Major League Electronics .100 cl Box Connector Socket Strip - Vertical

BCSS-1-SV SERIES	.100 cl Single Row Box Connector Socket Strip - Vertical	12 JAN 07	Scale NTS
<small>UNLESS OTHERWISE SPECIFIED DIMENSIONS IN INCHES (MM) TOLERANCES ARE: ONE PLACE DECIMALS ±.100 TWO PLACE DECIMALS ±.010 THREE PLACE DECIMALS ±.005 FOUR PLACE DECIMALS ±.0020 ANGLES 35°</small>		4235 Earnings Way, New Albany, Indiana, 47150, USA 1-800-782-3486 (USA/Canada/Mexico) Tel: 812-944-7244 Fax: 812-944-7268 E-mail: mle@mlelectronics.com Web: www.mlelectronics.com	
		Revision C

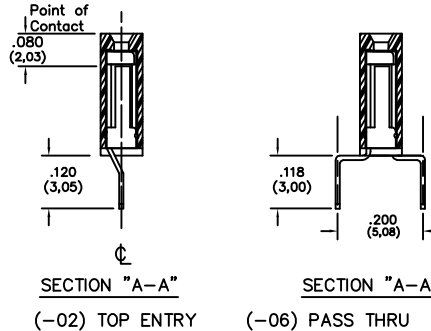
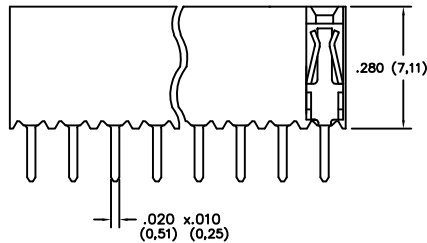
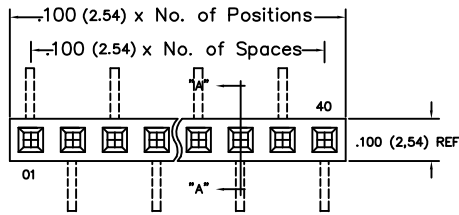
Revision B - (16th Sept 2008)

Body height changed from .280 (7.11) to .335 (8.51)

Revision C - (17th Oct 2008)

Body height changed back to .280 (7.11) in line with the release of TBCSS-1-SV which now features the .335 (8.51) body height
